Title - Sujet IOS MCTS Renovation	
Solicitation No. - N° de l'invitation EZ899-211223/A	Amendment No. - N° modif. 001
Client Reference No. - N° de référence du client	Date 2020-10-30
GETS Reference No. - N° de référence de SEAG PW-\$PWY-043-8849	
File No. - N° de dossier PWY-0-43116 (043)	CCC No./N° CCC - FMS No./N° VME
Solicitation Closes - L'invitation prend fin at - à 02:00 PM on - le 2020-11-10	Time Zone Fuseau horaire Pacific Standard Time PST
F.O.B. - F.A.B. Plant-Usine: <input type="checkbox"/> Destination: <input checked="" type="checkbox"/> Other-Autre: <input type="checkbox"/>	
Address Enquiries to: - Adresser toutes questions à: Dumay (PWY), Clara	Buyer Id - Id de l'acheteur pwy043
Telephone No. - N° de téléphone (604) 499-9708 ()	FAX No. - N° de FAX () -
Destination - of Goods, Services, and Construction: Destination - des biens, services et construction: DFO – Institute of Ocean Science – Sidney, BC

This Amendment 001 is raised to incorporate Addendum No. 1.

Photos for reference

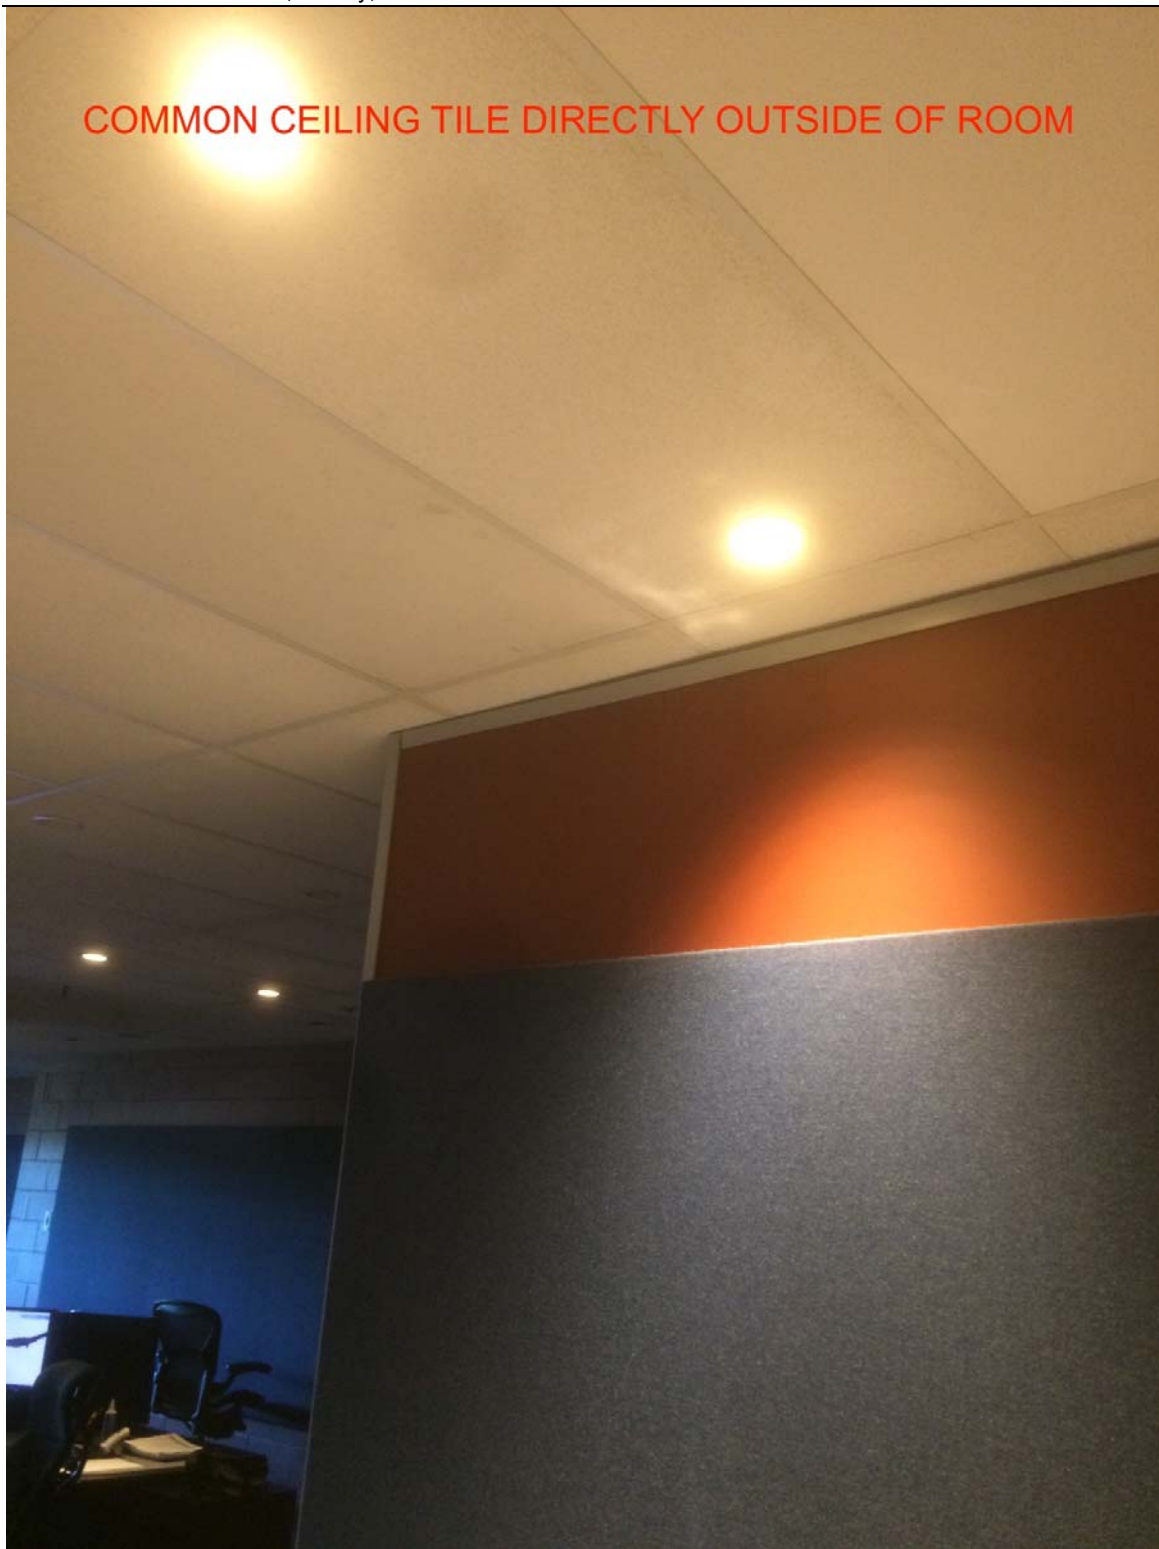
- .8 For the relocated floor grilles shown on detail 2/M1.00 between gridlines E and F along gridline 2.5, please confirm where these ducts are being fed from. The same question applies to the grille shown at gridline D"/1.6. There doesn't appear to be an HVAC duct branch shown that feeds these locations.

RESPONSE: The floor grilles to be relocated and added are utilizing the floor plenum and therefore no duct connections required for these grilles.
